Office Action Summary

10/575,856

LEE, DUCK GIL

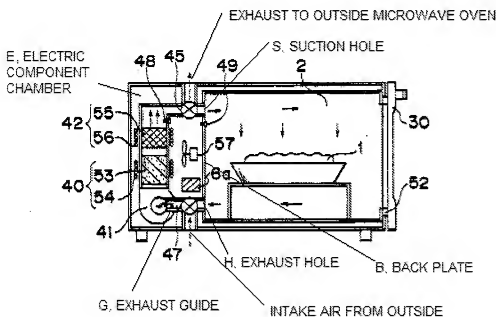
5. Claims 1, 3, 6, 11-13, 16 are rejected under 35 U.S.C. 102(b) as being anticipated by Yoneno et al (US 5,525,782) new cited.

Yoneno shows an electric combination oven with humidity conditioner comprising: a cavity (2) for accommodating foods therein; an electric component chamber (E, figure below) disposed at a predetermined portion of the cavity; a suction hole (S, figure below) formed at one sided portion (upper side portion) of the cavity such that the cavity communicates with the electric component chamber (E); an exhaust hole (H, figure below) formed at the other sided portion (lower side portion) of the cavity, through which air sucked through the suction hole is exhausted; an exhaust guide (G, figure below) covering an outer wall of the cavity where the exhaust hole (H) is formed, for guiding air exhausted through the exhaust hole (H) to an outside of the microwave oven (see figure below); and a back plate (B, figure below) having an exhaust passage hole (H) communicating with one end of the exhaust guide (G), through which air is exhausted (figure below). Similarly, the claimed structure in claim 13 is also met: an air flow passage of a microwave oven comprising: a suction hole (H)

formed between a plate on which foods (a dish of food) are placed and a cavity 2, through which air of an electric component chamber (E) is introduced; an exhaust hole (H) through which air introduced through the suction hole (S) is exhausted; an exhaust guide (G) for guiding air exhausted through the exhaust hole (H) to an outside of the microwave oven; and a back plate (B) having an exhaust passage hole (H) for exhausting the air guided by the exhaust guide to an outside of the microwave oven.
